January 20, 2015

**Re: Comment re: Draft Environmental Impact Statement for the Proposed  
Section 24 Specific Plan Agua Caliente Band of Cahuilla Indians  
(SCH No. 2014011035)**

**Figure 1.** Google Earth imagery from 2012 shows the linkages of open space south of I-10, and how converting Section 24 (red boundary) to houses will eliminate the ability of terrestrial wildlife to move (orange arrows) into and out of >2,500 acres of open space.

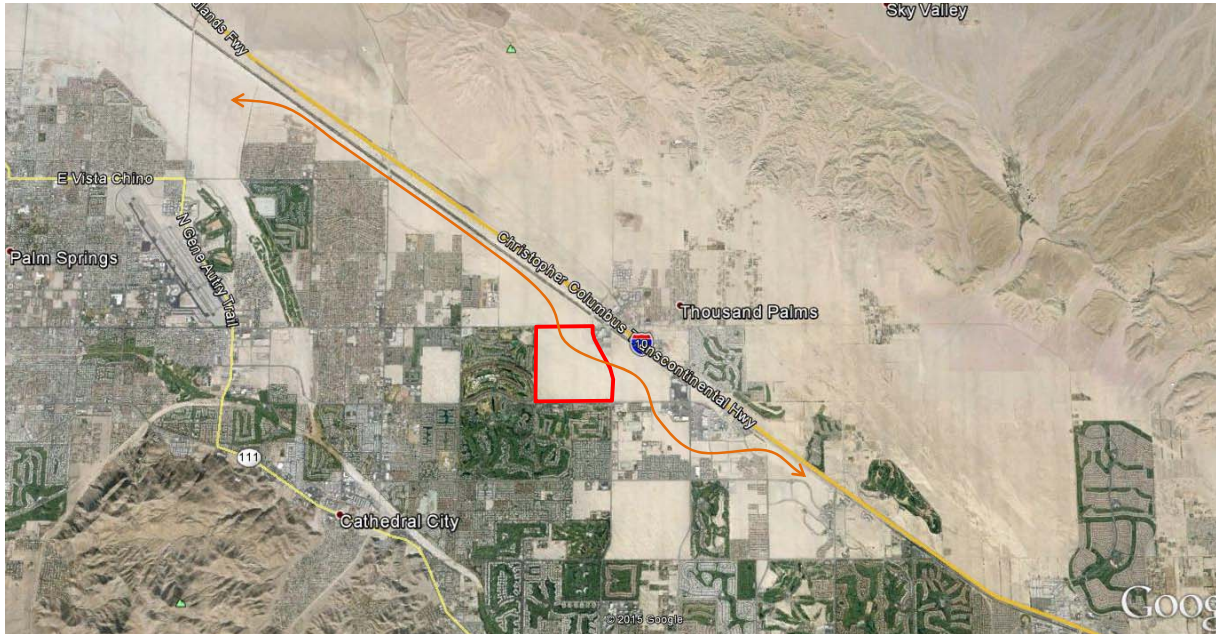
Dr. Cashen concludes that the Project will have adverse impacts on wildlife movement corridors. Dr. Cashen states:

Section 24 represents a chokepoint to wildlife movement, so losing it to another residential project will block movement of wildlife along the northwest-southeast band of open spaces south of I-10. Converting Section 24 to urban housing will not only remove 577 acres of habitat of many wildlife species, but will also effectively remove the habitat capacity of at least 2,500 acres of additional habitat southeast of Section 24. The additional impacts are readily apparent in Figure 1, and should not be ignored in the EIS.

This impact must be analyzed and mitigated in a supplemental DEIS.
